CITY OF FRANKLIN
PLAN COMMISSION MEETING*
FRANKLIN CITY HALL COUNCIL CHAMBERS
9229 W. LOOMIS ROAD, FRANKLIN, WISCONSIN
AGENDA
THURSDAY, DECEMBER 1, 2022, 7:00 P.M.

CITY OF FRANKLIN
REPORT TO THE PLAN COMMISSION
Meeting of December 1, 2022
Major Amendment to PDD No. 37

Project name:	M1 mixed use building, PDD Major Amendment to allow for ground floor apartments and 692-sf studio apartments
Property Owner:	Zim-Mar Properties, LLC
Applicant:	M1 at Ballpark Commons, LLC
Agent:	Emily C. Cialdini. Mandel Group, Inc.
Property Address/TKN:	SE corner of Rawson Ave and Ballpark Dr / 754 9006 000
Aldermanic District:	District 2
Zoning District:	PDD 37 – The Rock Sports Complex/Ballpark Commons
Staff Planner:	Régulo Martínez-Montilva, AICP, Principal Planner
Submittal date:	10-06-2022
Application number:	PPZ22-0162

Date: November 11, 2022
To: Emily Cialdini. Mandel Group, Inc.
From: Department of City Development
Régulo Martínez-Montilva, AICP, Principal Planner
RE: Staff comments for Major PDD Amendment, M1 Building at Ballpark Commons (BPC)
SE corner of Rawson Ave and Ballpark Dr / 754 9006 000

BALLPARK COMMONS M1
8240 OLD LOOMIS RD
FRANKLIN, MILWAUKEE COUNTY, WI
NATURAL RESOURCE PROTECTION PLAN

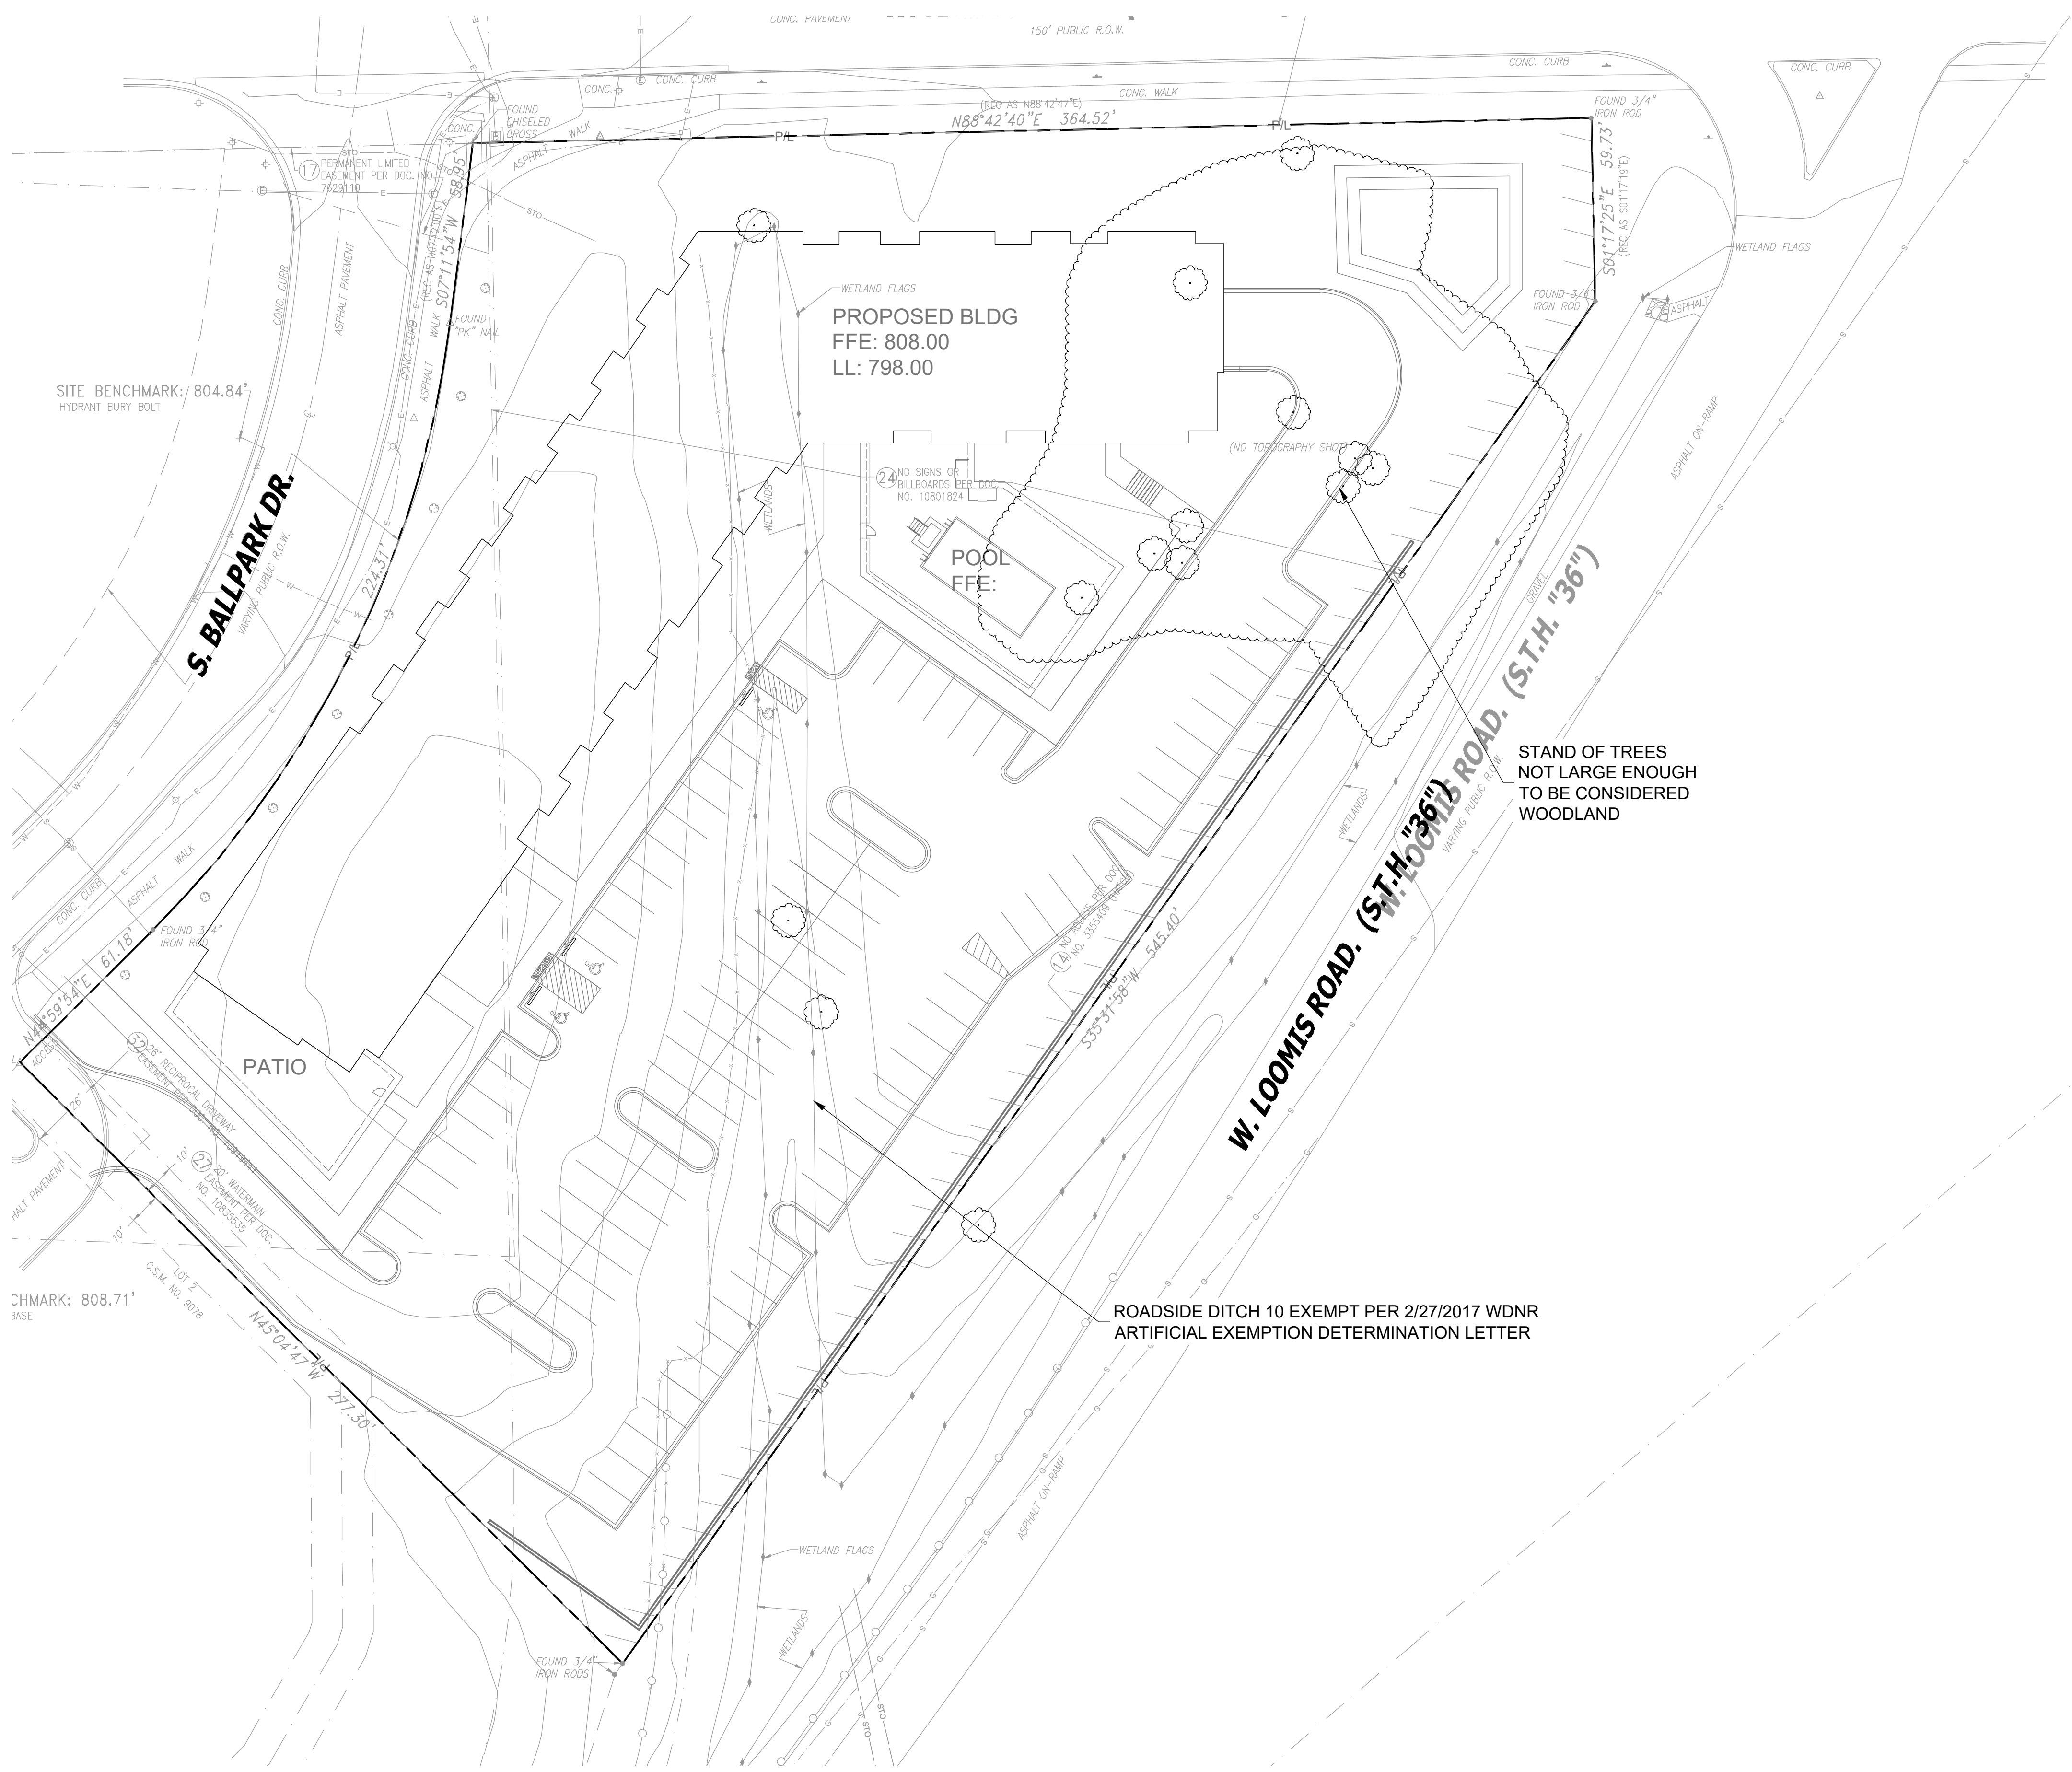
Staff comment: Along S. Ballpark Drive, ground floor commercial/retail/office uses will benefit from the proximity to the existing sidewalk. Along Rawson Avenue, a 30-foot landscape bufferyard runs along the entire frontage which creates a barrier between the proposed building and the existing sidewalk, so ground floor apartments are appropriate along Rawson Avenue due to the privacy and noise barrier effect of the landscape buffer (see landscape plan sheet L100).
